**SECOND AMENDMENT
TO
CONSULTANT AGREEMENT**

Re: Project #14DSD120313 – Copper Sky Police Department Sub-Station
Change Order Request #3 – Post Construction Services – Various Projects

Copper Sky Police Sub-Station -
Change Order #3 Diagram
Architekton October 17, 2017

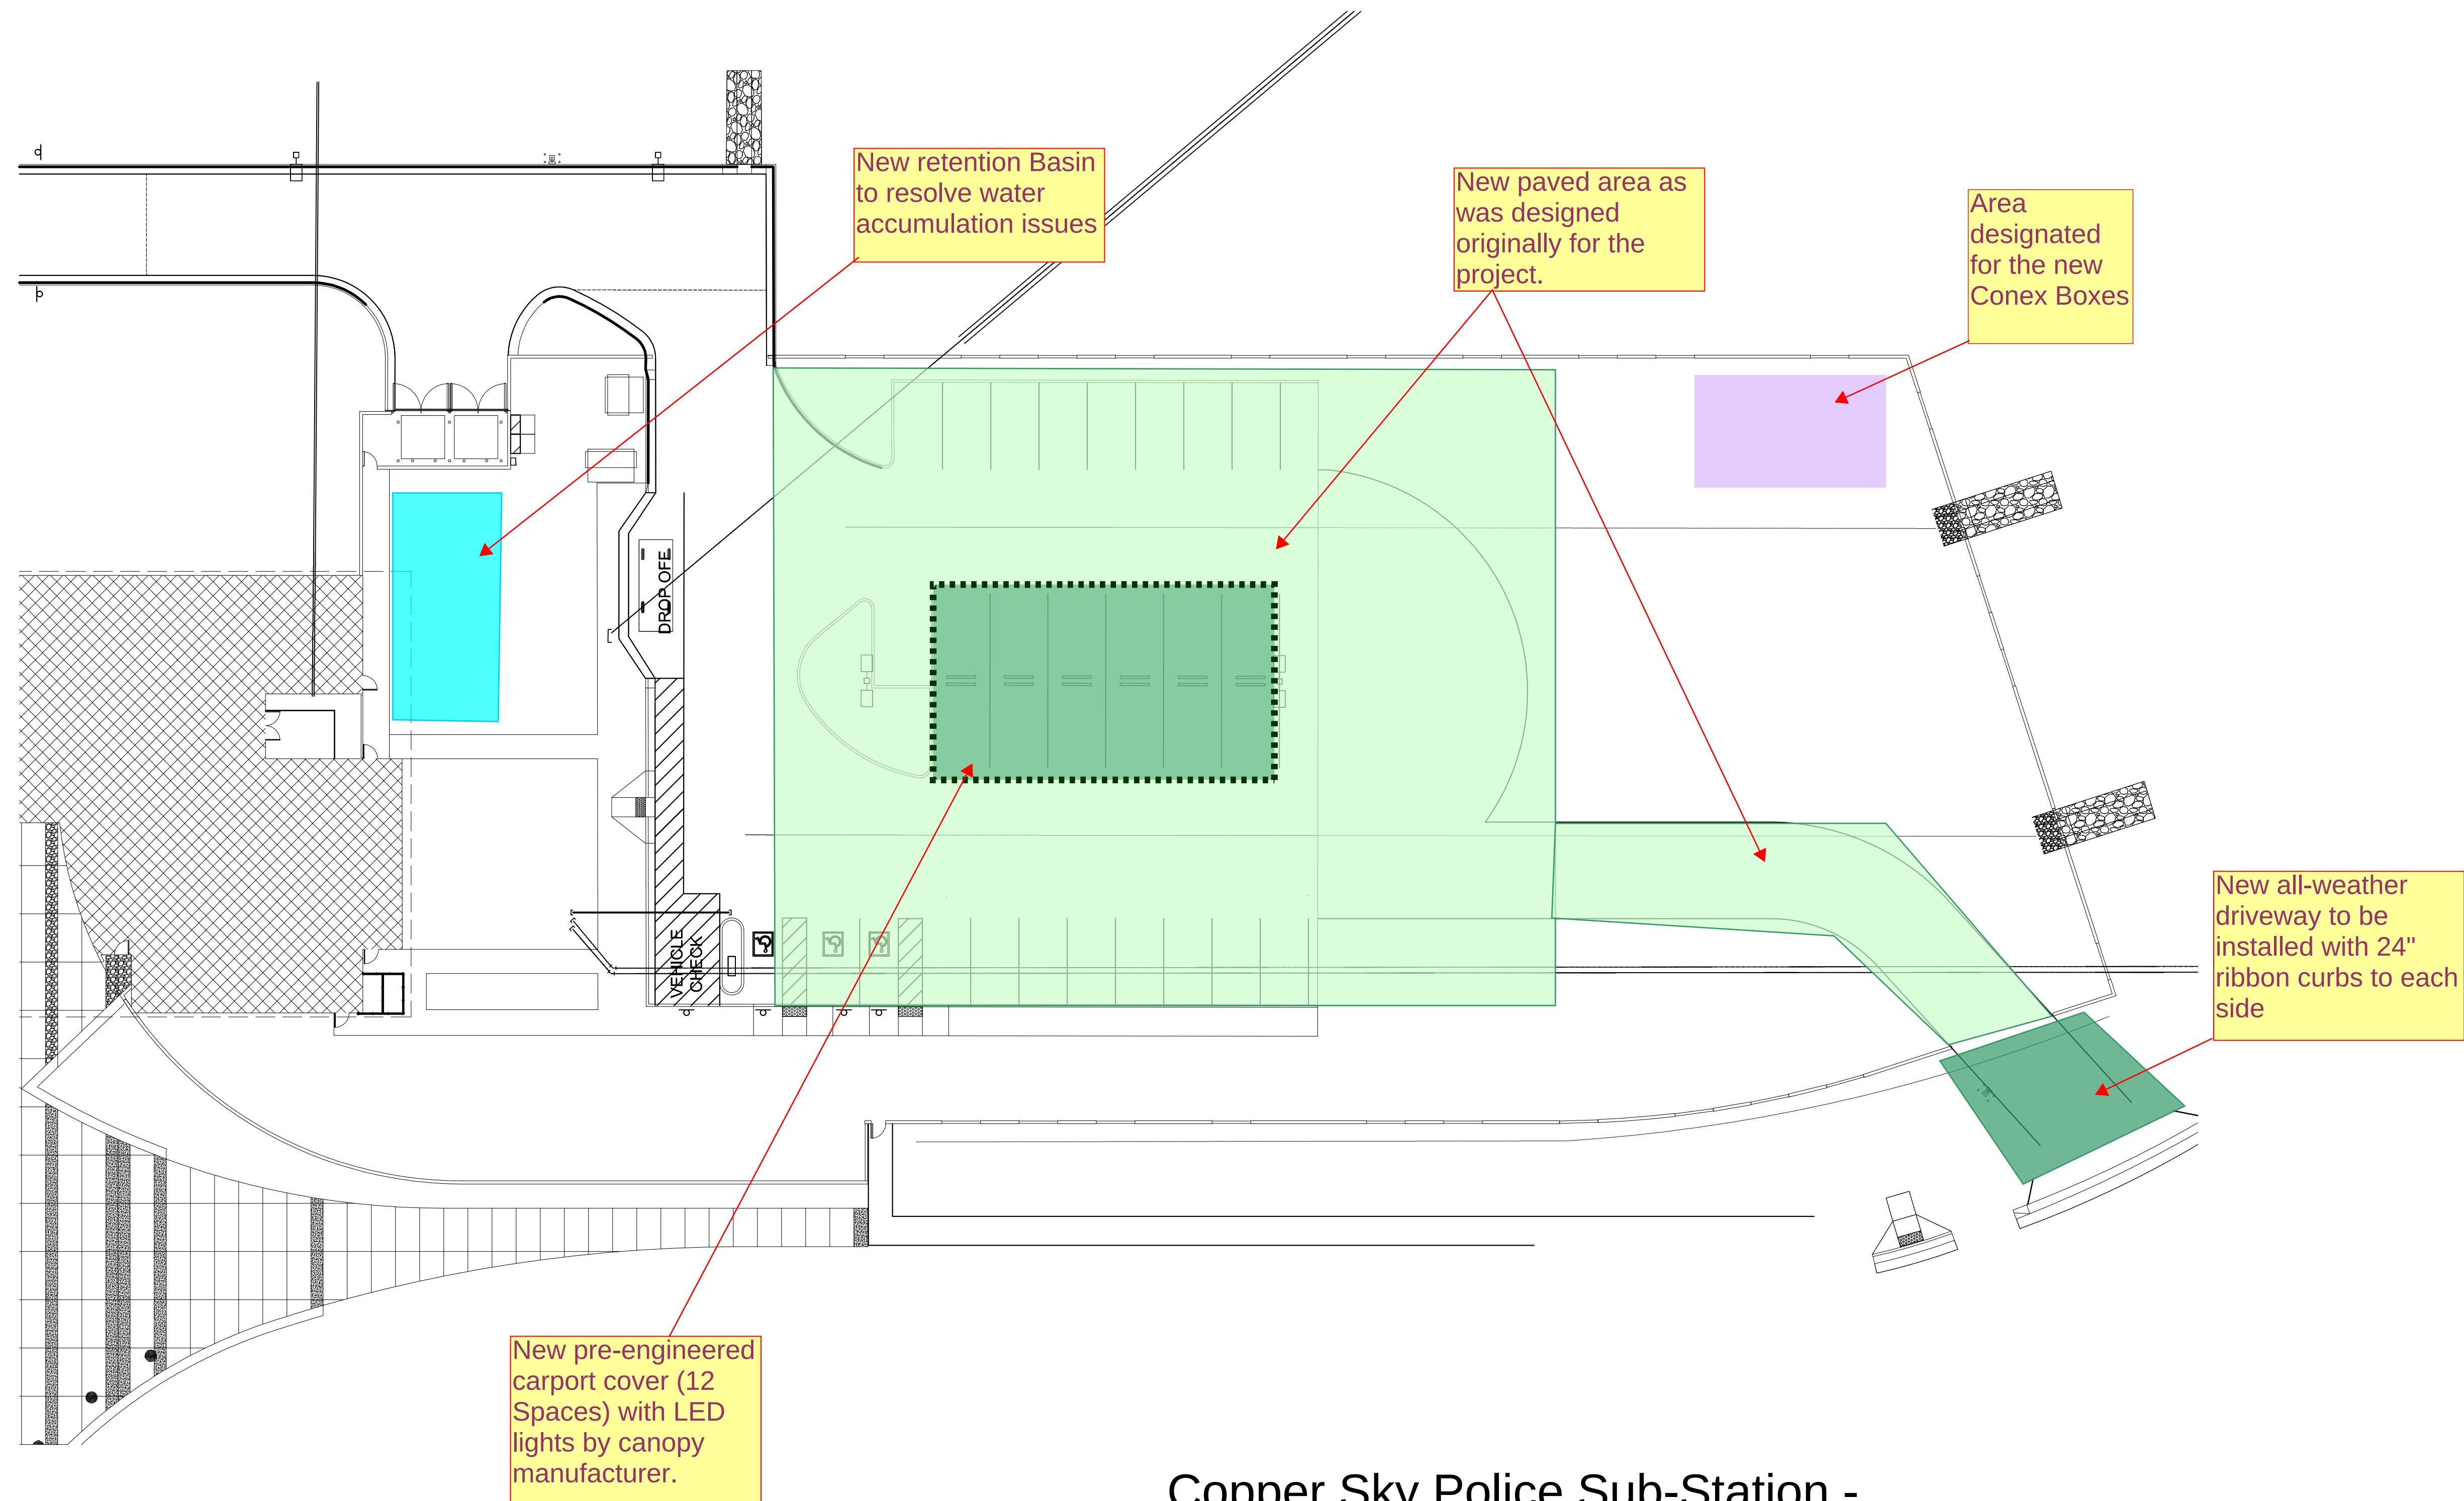
1. The Maricopa Police Department (MPD) will be procuring 2 Conex Boxes with air-conditioning. The Conex boxes will be located on the north side of the fenced area adjacent to the masonry wall. The design team is asked to design power to the Conex boxes in the form of one 60-amp panel at each Conex Box location.

2. MPD has asked for a new driveway at their rear gate entrance of the secured parking lot. They would like to replace the decomposed granite (DG) landscape with an all-weather surface in the ROW area leading up to the existing gate. They are requesting a 24" ribbon curb flush with the all-weather drive between the all-weather driveway and the DG landscape areas.

3. MPD would like to extend the asphaltic paving in the east secured parking lot as it was proposed in the initial construction. (See the attached sketch)

4. MPD would like to resolve roof drain issues they have been experiencing at the east side of the building by installing a small retention basin at the east side DG area where the water accumulates.

5. Redundant refrigeration system and alarm system for the Evidence Refrigerator and Freezer. Since the design services for this work is not known now, an allowance will be included in the proposal for this work.

6. MPD would like to add pre-engineered parking lot canopies over the middle parking spaces in the east secured parking lot. The canopies and their foundations will be designed, constructed and permitted by the subcontractor. The subcontractors work includes the light fixtures attached to the canopy. The general contractor will extend the electrical circuit from an adjacent light pole to power the lights on the canopy. The design team will locate the canopy on the plans.
